SNUPPS

SLNRC 83-0039 FILE: 0491.10.2
SUBJ: Interim Report: Westinghouse
7300 Process Protection
System (SDR 83-08)

Docket Nos. STN 50-482 and STN 50-483

Attachments: 1. Superseded Drawing 404A605
2. Drawing 403A947

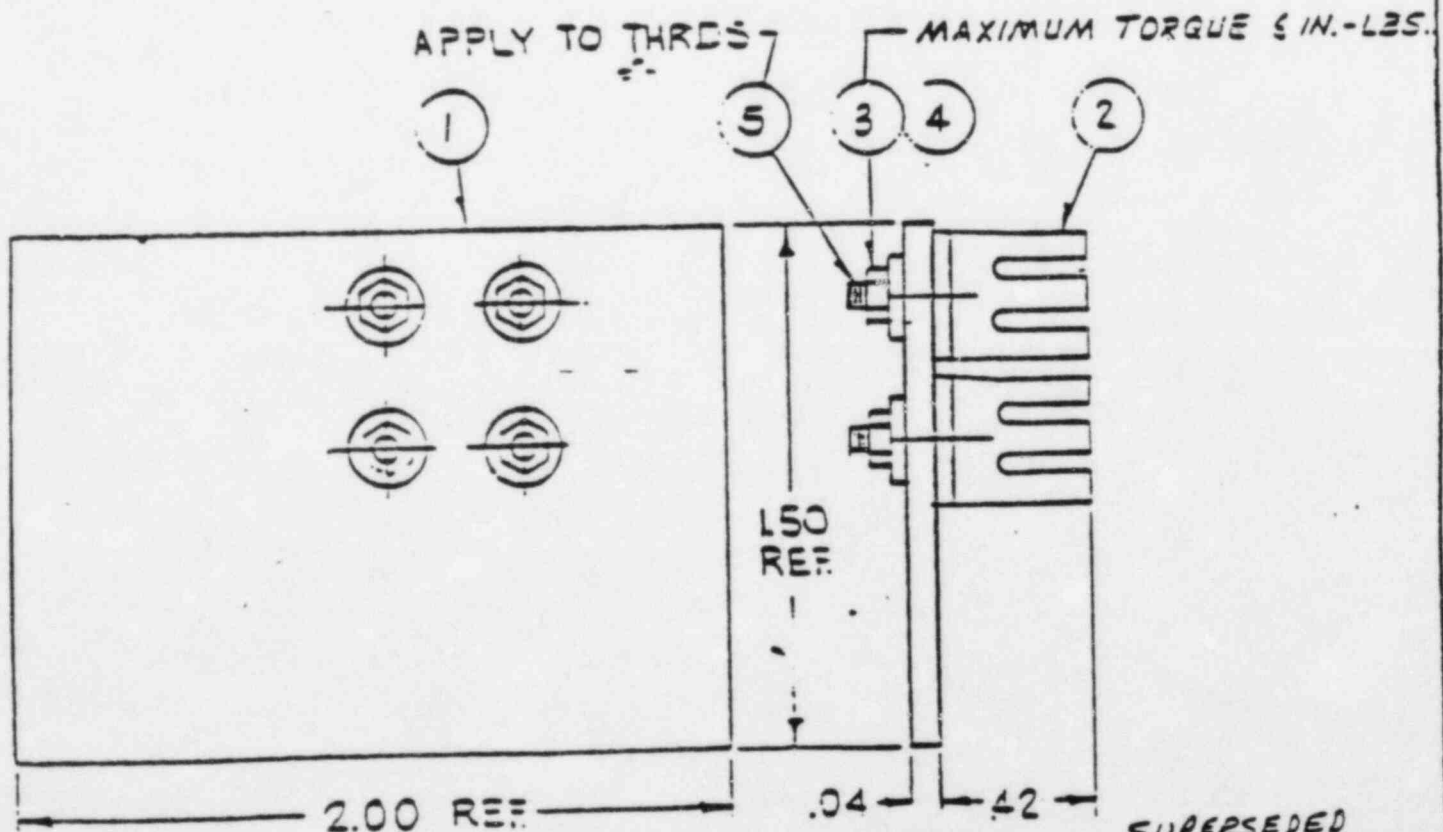
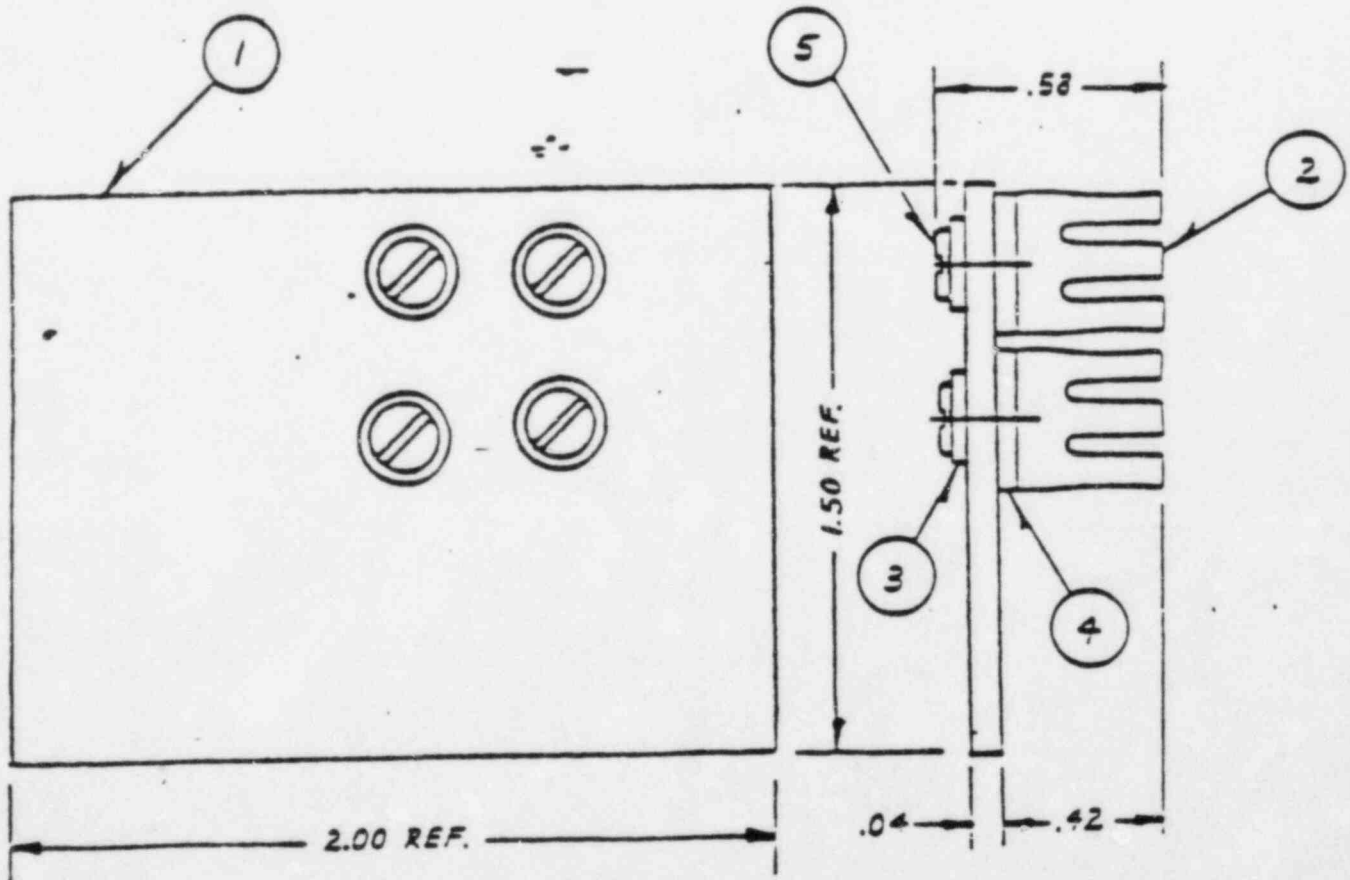
Heat sink adhesive failures have been identified at several plants other than Callaway or Wolf Creek and were reported to Westinghouse as field deficiencies. All reported field failures have occurred only on the loop power supply (NLP) cards. Westinghouse has determined that NLP printed circuit cards shipped from Westinghouse Industry Electronics Division (WIED) between August 1, 1980 and September 1, 1982, were equipped with a thermal heat sink assembly on the inverter transistors. The heat sink assemblies are subject to potential failures in the adhesive bond between an insulating washer and the thermal link (see Attachment 1). The affected printed circuit boards are:

If the adhesive bond defect had remained undetected, failure of the bond could cause the heat sink plate to separate from the thermal links and fall off the printed circuit board. The plate is conductive metal and under certain circumstances could cause shorting of low level signals if it were to become wedged between cards in the card frame. These low level signals are associated with various protective functions within a given Protection Set of the 7300 Process Protection System Cabinets. For example, one such protective function is the Pressurizer Pressure (2 of 4 Logic) Reactor Trip. Under the unlikely condition of three concurrent adhesive failures in three different cabinets, each resulting in the shorting of one of the four logic signals generating the trip function, it is possible that reactor trip would be delayed, and that fuel temperatures would exceed those presented in certain FSAR analyses.

Heat sinks that are subject to this potential adhesive failure mechanism will be identified by Westinghouse and replaced. These heat sinks will be identified by inspection of the printed circuit card for hex nuts visible on the top side of the assembly. See attached, superseded drawing 404A605 (Attachment 1). The replacement heat sinks have screw heads visible from the top side of the assembly (see Drawing 403A947, Attachment 2). The new style replacement heat sink cards feature screws that penetrate the heat sink material and hold the material securely in place.

NOTE: SUPERSEDED BY
DWG. 403A947G01 FOR OLD
OR NEW DESIGN.

1-TO RETROFIT TO EXISTING P.C. BOARD ASSEMBLIES, MOUNT THERMAL LINK 17.2 TO TRANSISTORS BEFORE ASSEMBLING TO HEAT SINK PLATE 17.1.
